BUILDING D

2A1-R

CONSTRUCTION SUMMARY

Forestside Estates Inc.

GROUND FL.

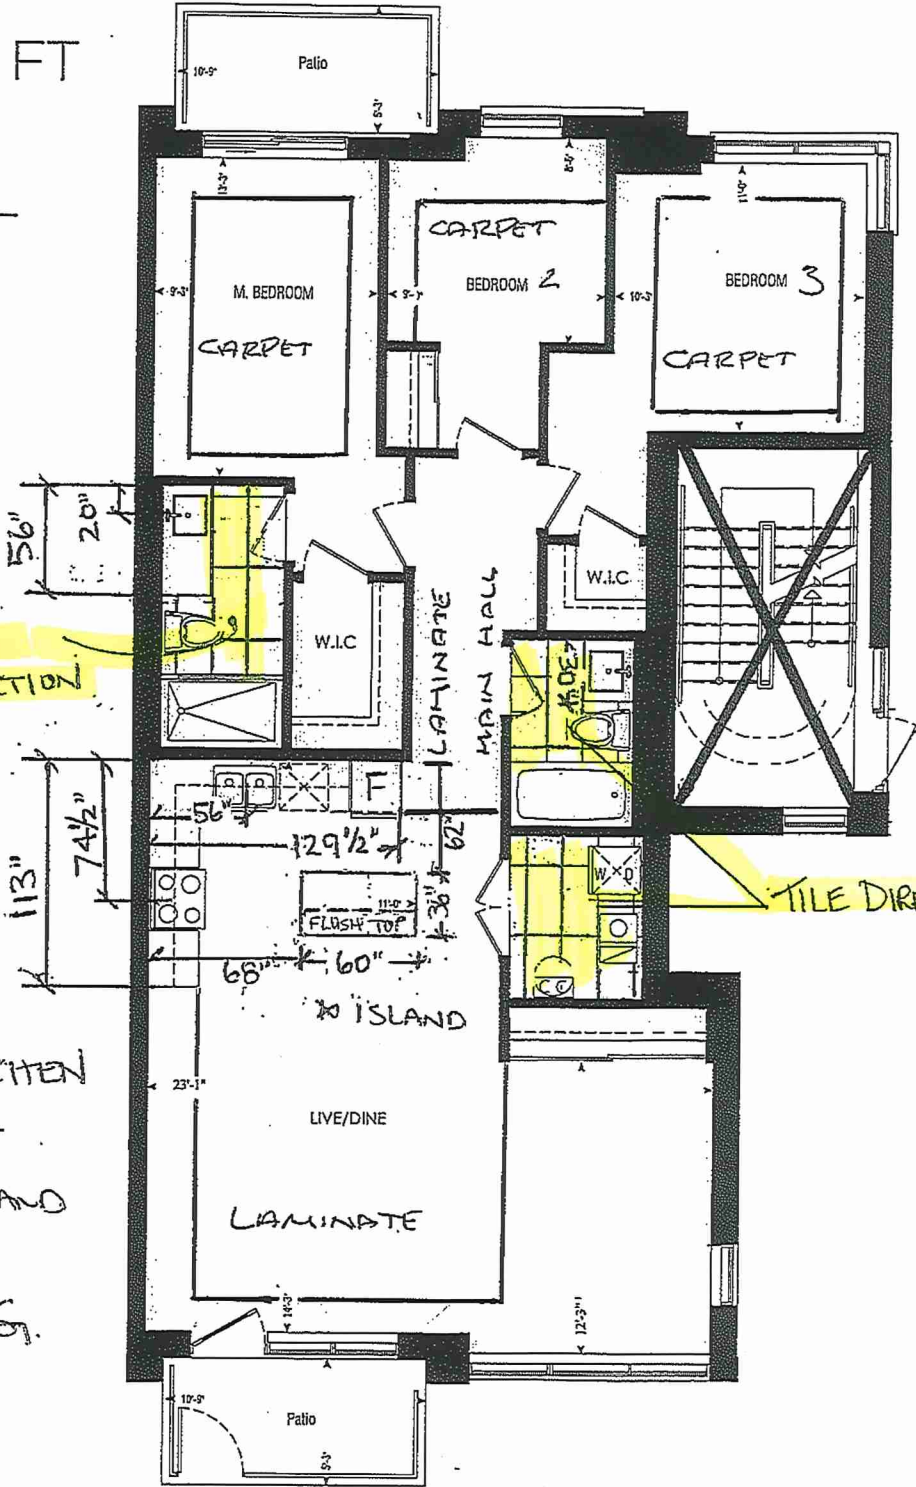
Note:
- 130 - MAIN FLOOR - FLOORING - Install UPGRADE 3 FLOOR TILES (12X24 LOFT WHITE) throughout the main floor where applicable in lieu of the builder's standard floor tiles. To be installed Stacked/ Straigh To include; Laundry/Mech. Room, Main Bath & Master Ensuite

Note: To be installed parallel to bathroom vanities/ Washer/ Dryer.(See Sketch)

KITCHEN PLAN

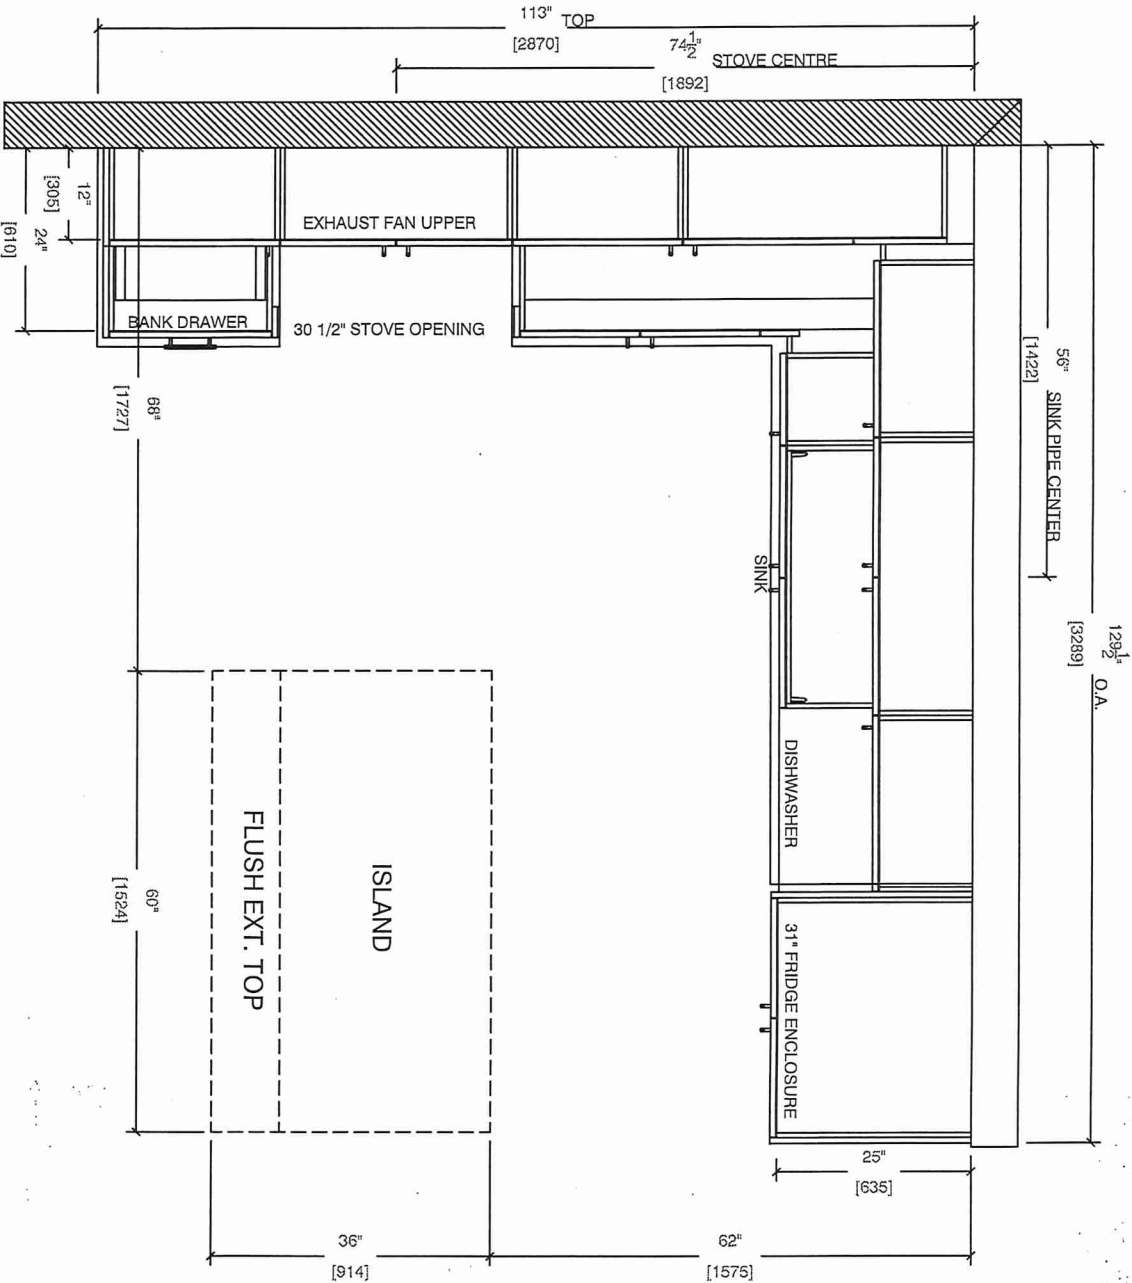
Master & Main Bath to be installed with standard shower wall tiles.
- 1 - KITCHEN & BATHROOMS - Purchaser has DECLINED All Upgrades offered during decor appointment at the decor centre for kitchen & bathroom cabinetry. Standard Kitchen Layout & Standard Bathroom Vanities to be installed as per standard plan. (See Sketch)

SINK WALL ELEVATION

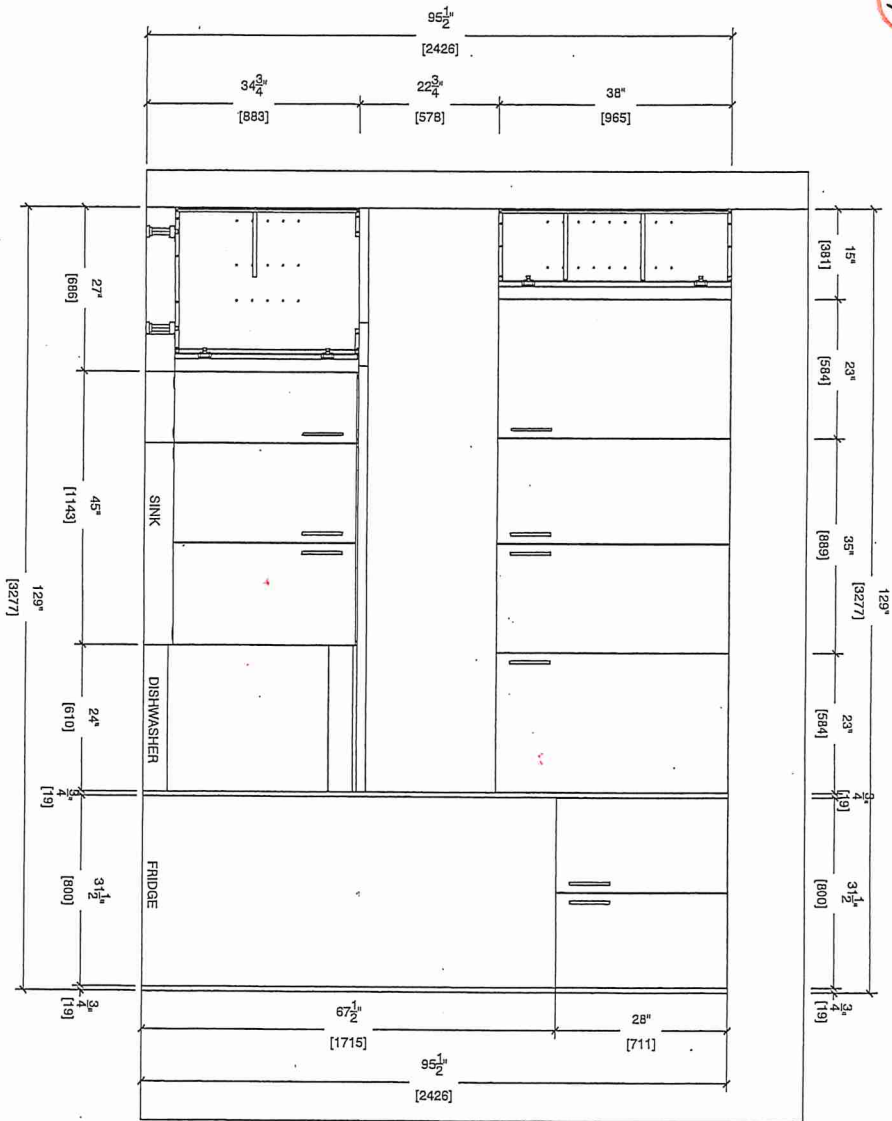
Note:
- 1 - KITCHEN - PLUMBING - Install the UPGRADED UNDERMOUNT sink in the kitchen- Install the BLANCO QUATRUS U1 SUPER SINGLE- Model # 401248. To include cut and polish (see sketch)

MASTER ENSUITE

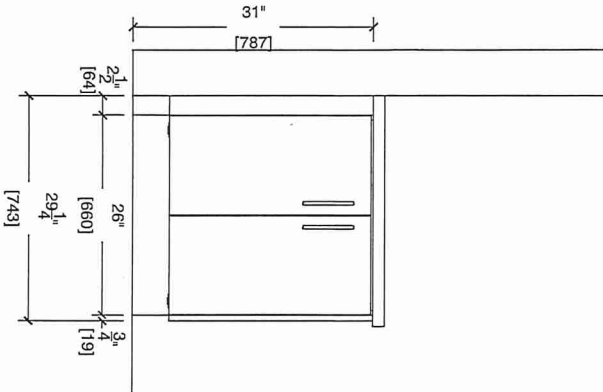
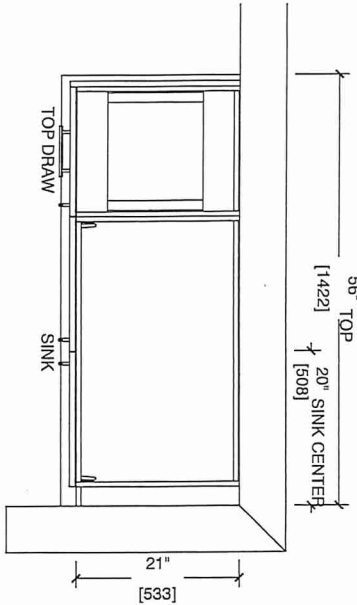
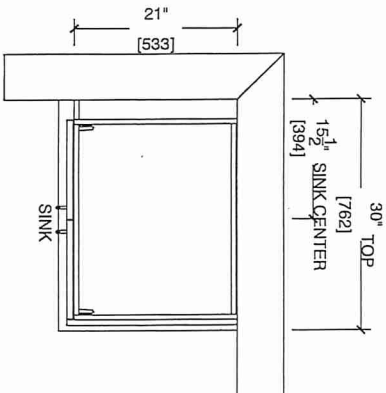
Note:
- 1 - MAIN BATH - COUNTERTOP - Install Builders Standard Stone Countertop - Emmerstone Maple White with STANDARD " A " EDGE PROFILE

- To be installed throughout the main bath where applicable. To include 3" Splash(See Sketch)

Note:
- 1 - MASTER ENSUITE - COUNTERTOP - Install Builders Standard Stone Countertop - Emmerstone Glacier White with STANDARD " A " EDGE PROFILE

- To be installed throughout the Master Ensuite where applicable. To include 3" Splash(See Sketch)

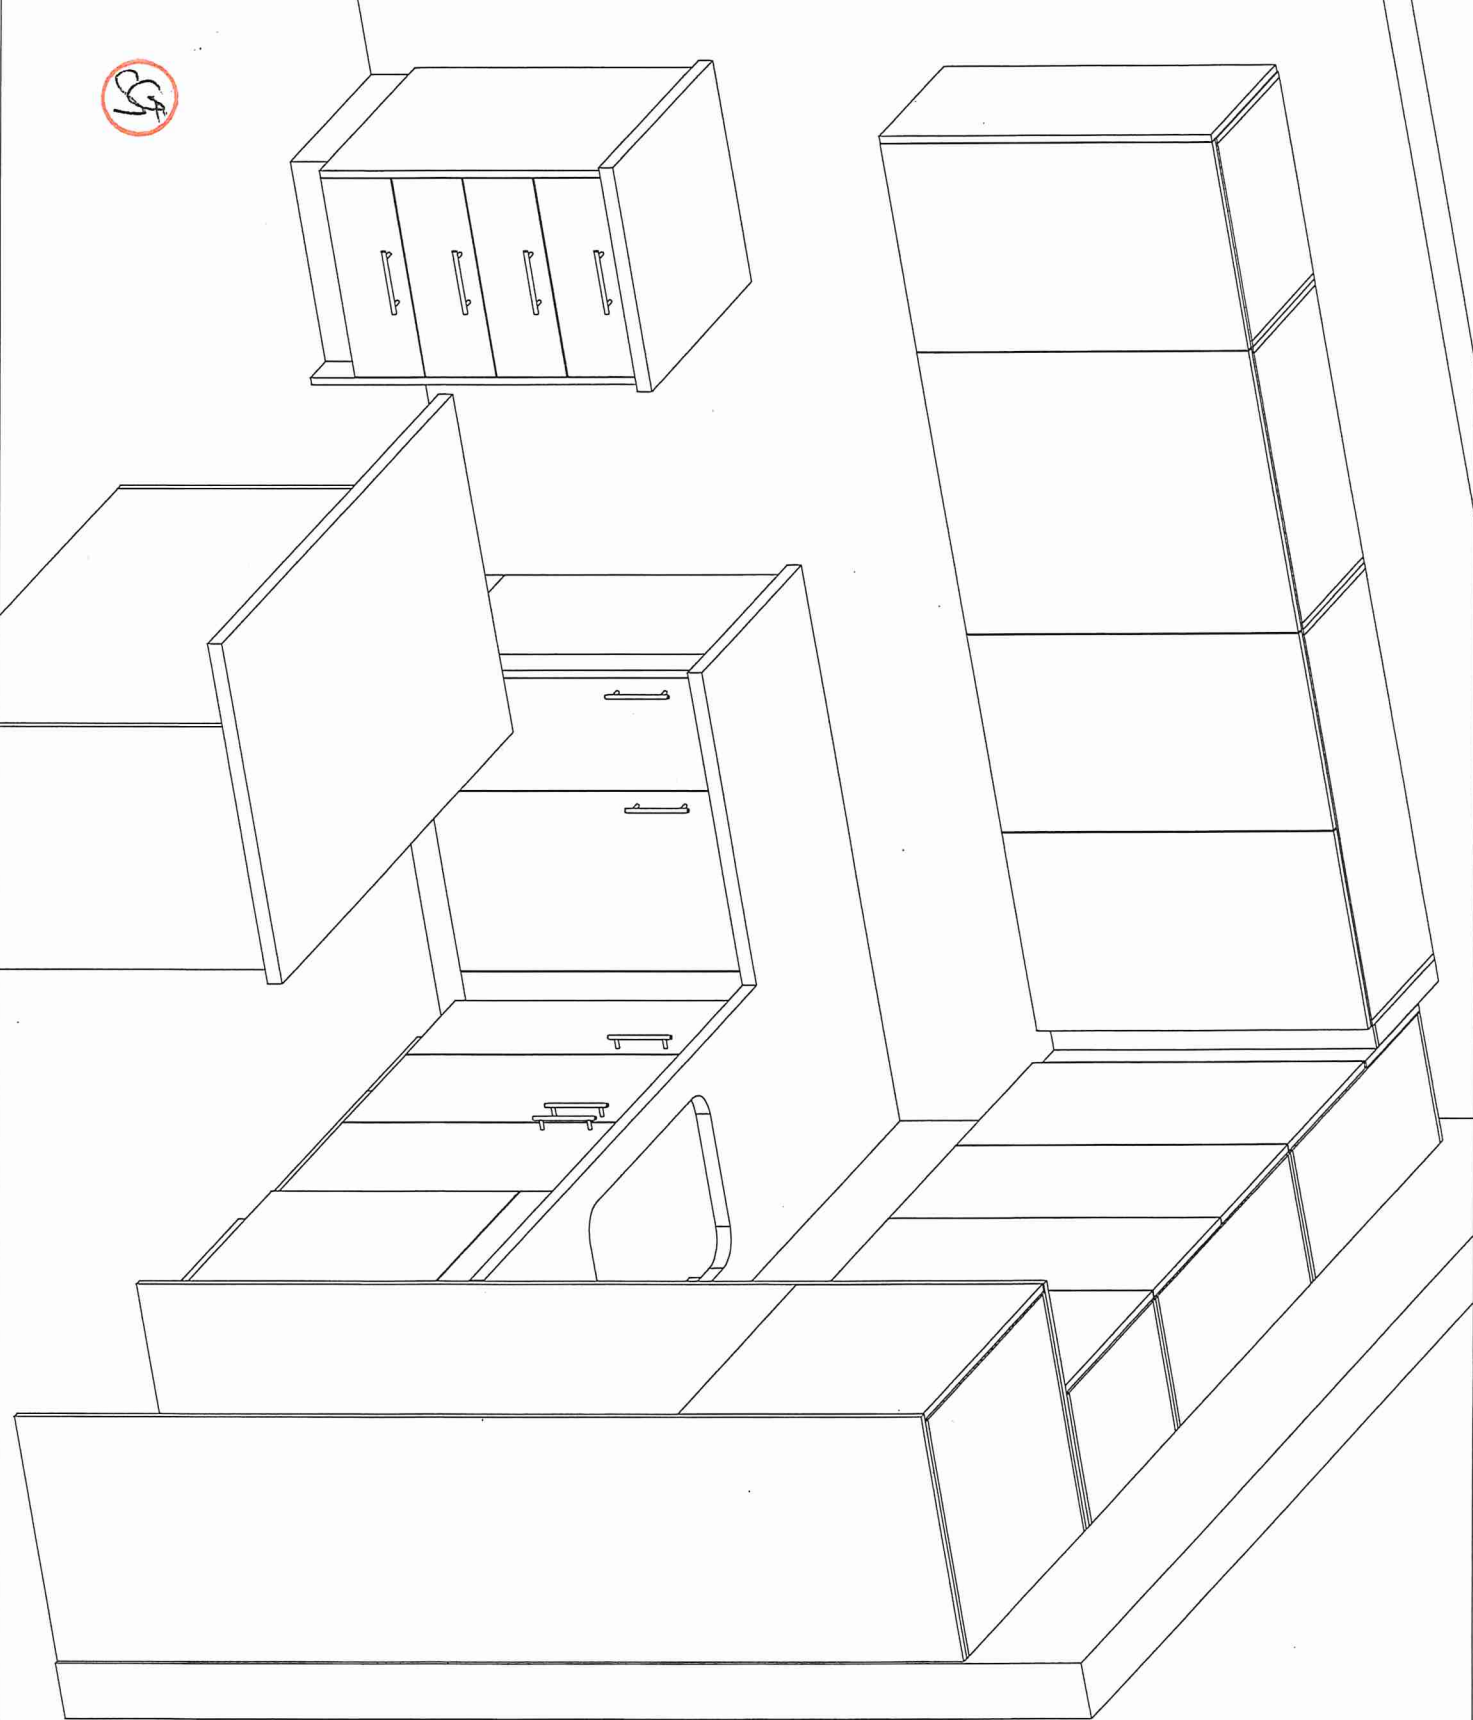
Note:
- 1 - KITCHEN - CABINetry- Install OPTIONAL ISLAND at the kitchen. To include pot and pan drawers (See Sketch)

Note:
- 1 - KITCHEN - COUNTER - Install stone countertop (Emmerstone Vanilla White) ontop of the OPTIONAL ISLAND with the Standard "A" edge. (See Sketch)
